ILLINOIS POWER COMPANY

Subject: 10CFR Part 21 Defect in
Rosemount Transmitter Amplifier Board
Functional Problem (21-84-10)

Subject: Notification Under 10 CFR Part 21 Regulations

OPERATIONAL AMPLIFIER LOCATIONS

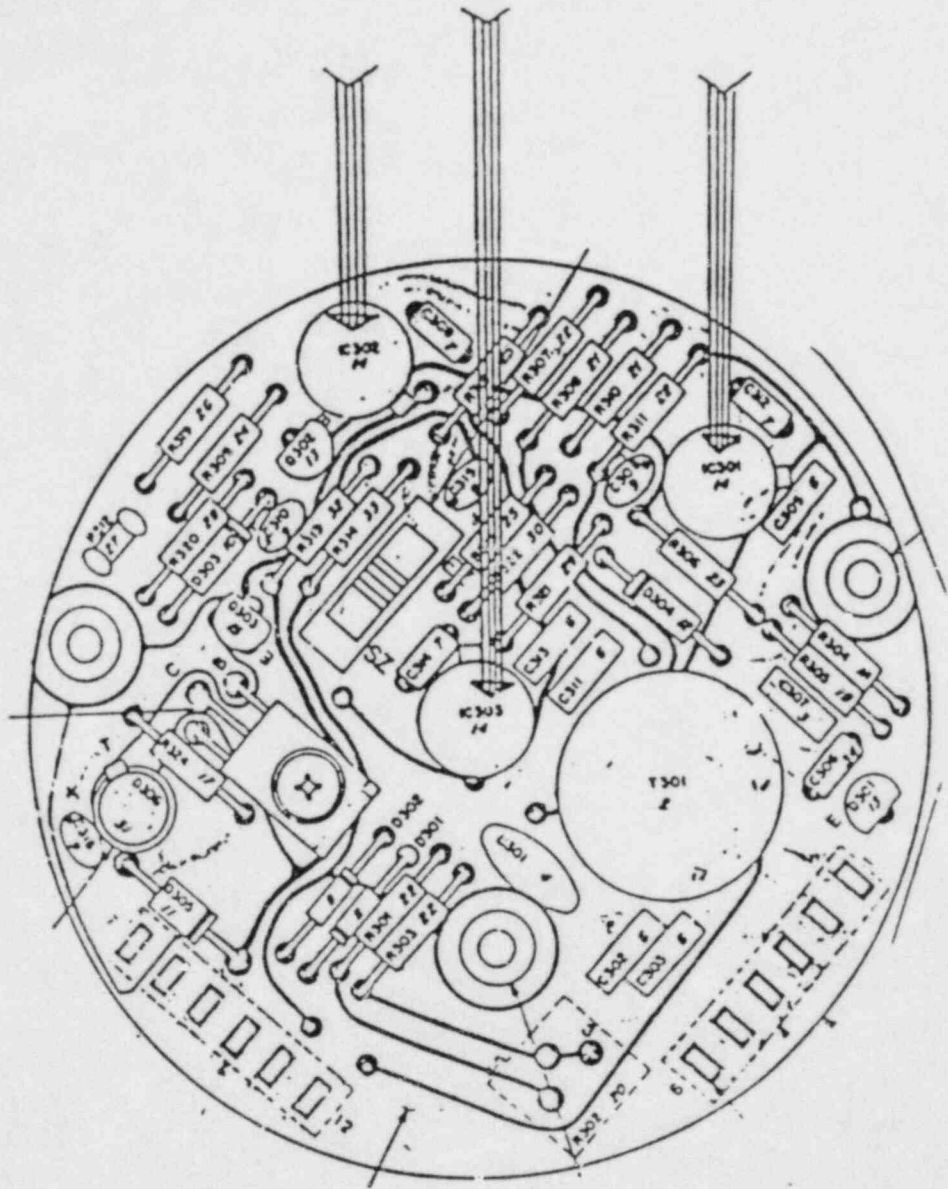
This suspected board can be identified visually by inspecting the circuit side of the board, and specifically the three operational amplifiers shown in the enclosed board layout print. The suspect board has Op Amps marked with the letters "PM", in addition to the date code on the top of the can. If your inspection finds this board, we are requesting you replace it with the one we have enclosed and then call Mr. R. Volsted at A/C 612-828-3473 for disposition of the replaced board.

SUSPECT MARKINGS

"PM"

ACCEPTABLE MARKINGS

"N" or "N20"
(No other markings)

If your inspection effort does not find the suspect board, we would like you to keep the enclosed amplifier board as a spare against your above referenced order. This is offered as the compliments of Rosemount for the inconvenience caused by this notification.
